AW 55-50SN Solenoid Fitment Information

Fitting late SLT & SLS valves on vehicles up to serial code 02E.

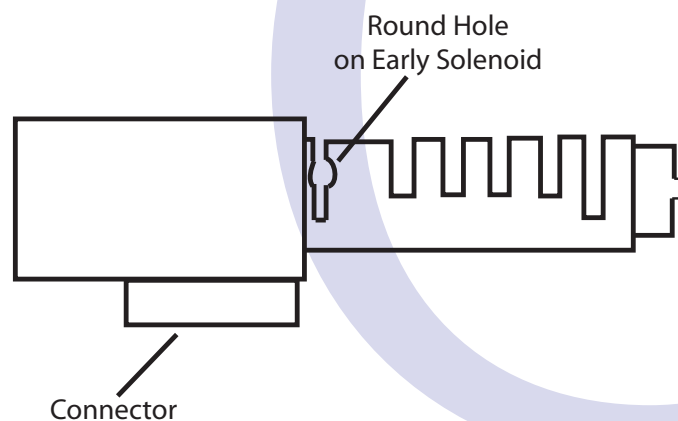
The phase one and phase two versions of these solenoids are now no longer serviced and it is necessary to fit the later phase three type solenoid

to do this you will require the following parts
1 x SLS solenoid 5550.SOL09, 1 x SLT solenoid 5550.SOL10,
& 1 x longer wiring loom 5550.ELE05.

It may also be required to modify the bracket on the SS1 solenoid, to prevent it fouling the new style SLS solenoid by elongating the hole in the mounting bracket so that it can be turned slightly, to give sufficient clearance.

It will also be necessary to check to see if you have phase one type solenoids using the illustration at the bottom of the page if you do, you will also need a modified holding bracket 5550.SOL12.
